## HARNETT COUNTY ENVIROMENTAL HEALTH

## Honeycutt Hills lot 24 T&J Panel Block, Tap Chart (Repair System)

Addendum to Report of Observations and Testing
Honeycutt Hills – Lot 24
417 Adams Pointe Court
Angier, North Carolina
Our Project Number 121-25-107043

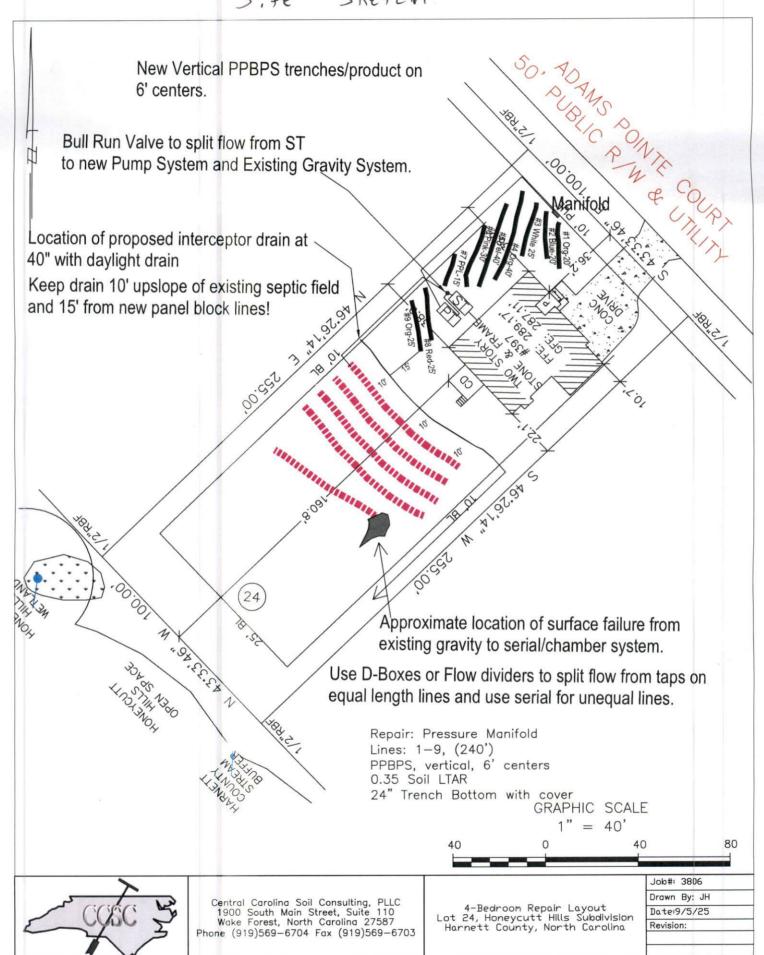
Our representatives were subsequently present at the site to observe the existing conditions with representatives of DRB Group North Carolina, LLC and Central Carolina Soil Consulting, PLLC. We were provided with Repair Layout for Prefabricated Permeable Block Panel System (PPBPS) with an interceptor drain for the septic system, designed by Central Carolina Soil Consulting, PLLC, dated September 5, 2025. The design provided is in substantial accordance with the recommendations provided in our letter dated August 8, 2025.
